# Access Report - Site Audit City of Port Phillip - The Avenue Children's Centre (13890)

# City of Port Phillip - The Avenue Children's Centre and Kindergarten

13890

Veradah post pinch point

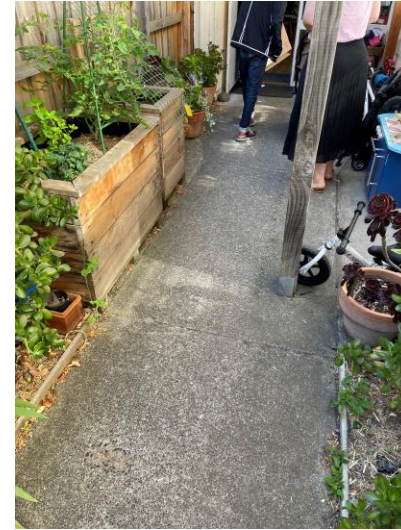
2.1	External Paths of Travel			
	Issue	Action	Rating	Comments
.1	Pathway to principal pedestrian entrance width less than 1000mm due to overgrown vegetation and positioning of verandah post which creates 870mm wide pinch point.	Ensure 1000mm minimum width provided for entire length of accessway. Trim vegetation; relocate/reinstall/remove verandah post.	R 	
.2	Overall external path width to building entrance.	Due to high likelihood of prams and strollers on straight pathway, consider expanding pathway to min 1500mm - 1800mm	A
